2075303 (WVA 20753) / 2310301 (WVA 23103)

TEXTAR® is harmonising the two references 2075303 and 2310301. 2310301 will cover applications of both part numbers in the future. Therefore 2075303 will be phased out.

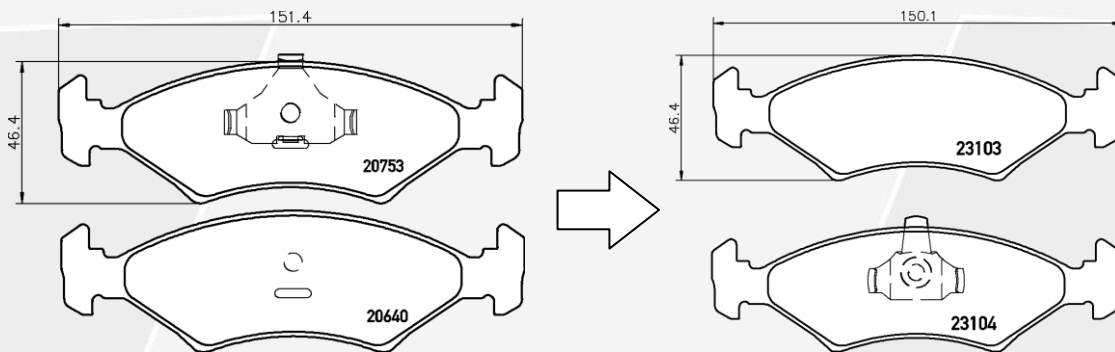
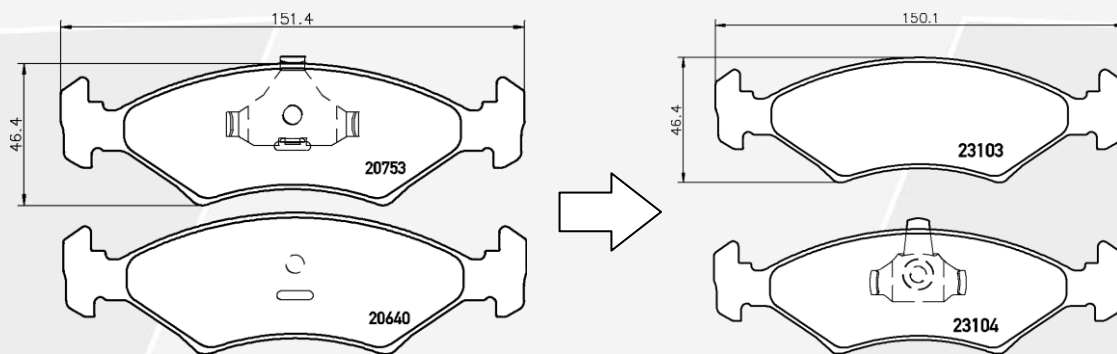
The parts differ in the way the piston clip is mounted on the back plate. Furthermore, the overall length of 2310501 is a bit smaller so that the pads can be fitted to those vehicles which previously used 2075303, without any problems.

Die beiden Artikel unterscheiden sich in der Kolbenhaltefeder und der Art wie diese an der Rückenplatte angebracht ist. Zudem ist die Länge über alles bei 2310301 ein bisschen geringer was es 2310301 erlaubt, ohne Probleme in Fahrzeugen verbaut zu werden, die bisher 2075303 nutzten.

Existing stock of 2075303 can be sold without any problems.
